# UNITED STATES PATENT AND TRADEMARK OFFICE

| APPLICATION NO. | FILING DATE | FIRST NAMED INVENTOR | ATTORNEY DOCKET NO. | CONFIRMATION NO. |
|-----------------|-------------|----------------------|---------------------|------------------|
| 10/749,073      | 12/30/2003  | Asad Ali             | 04428 (3883.00033)  | 7941             |

# Office Action Summary

**Figure 1**

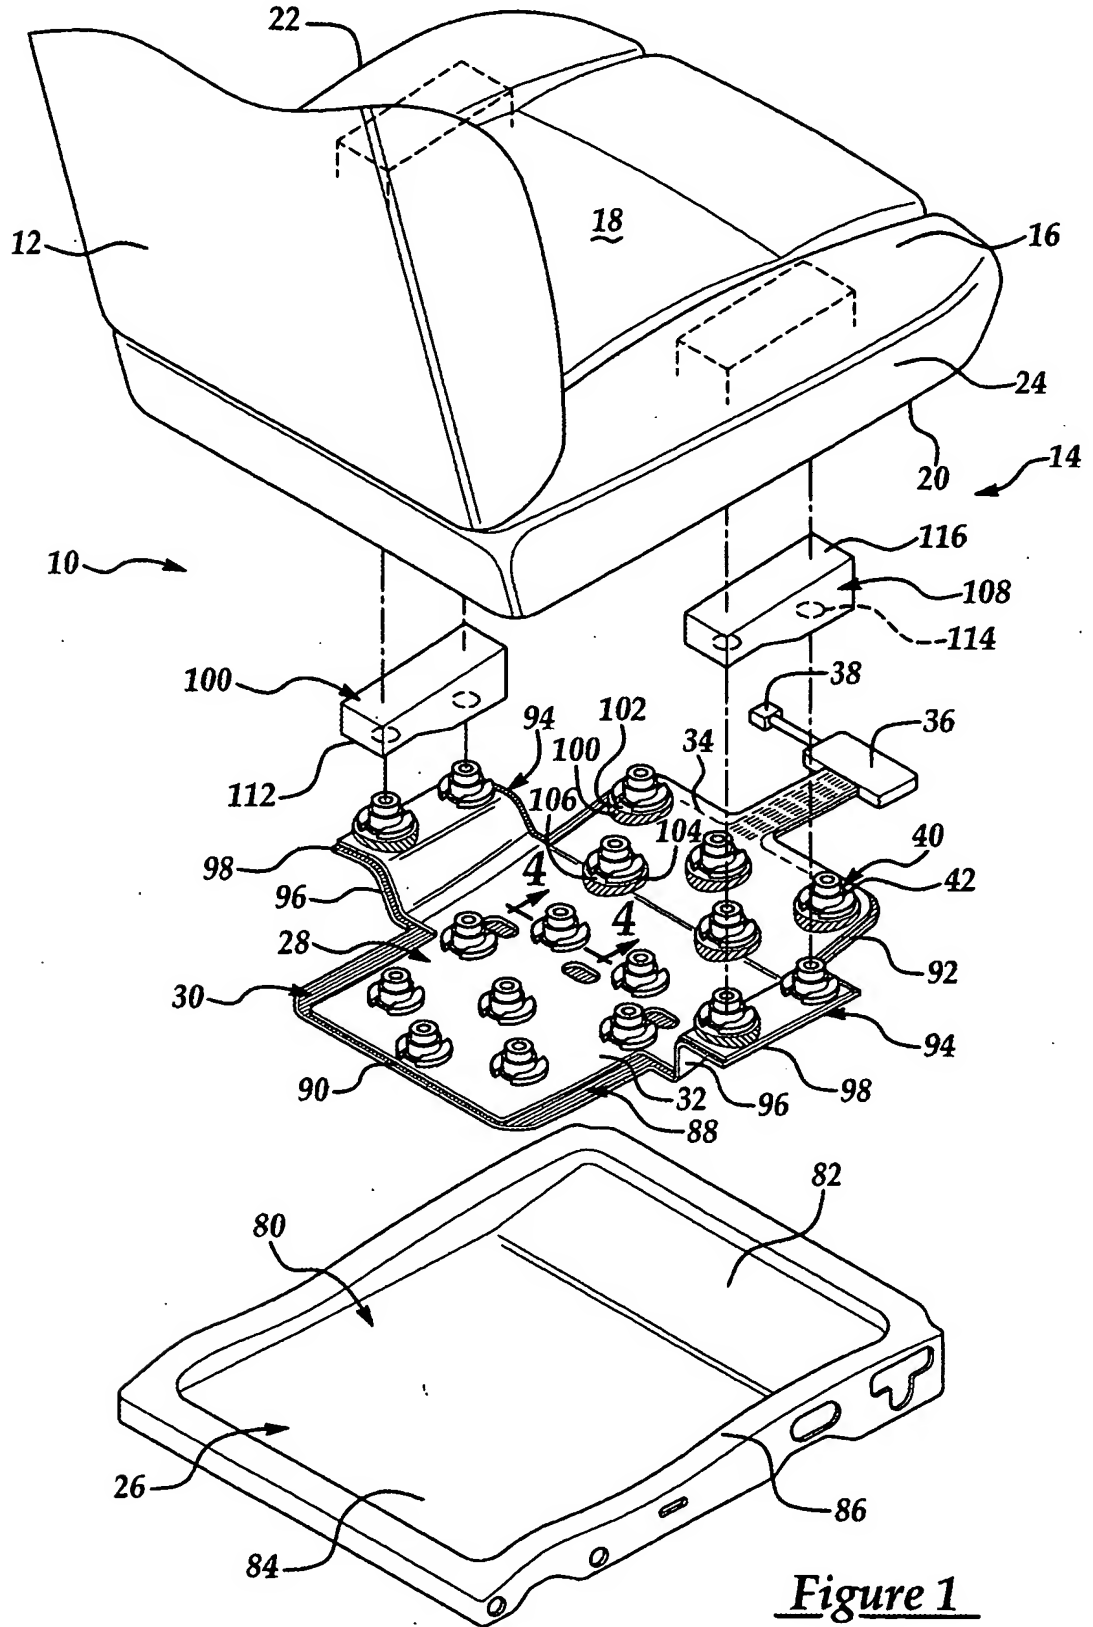
*disapproved  
 mh 8/8/05*
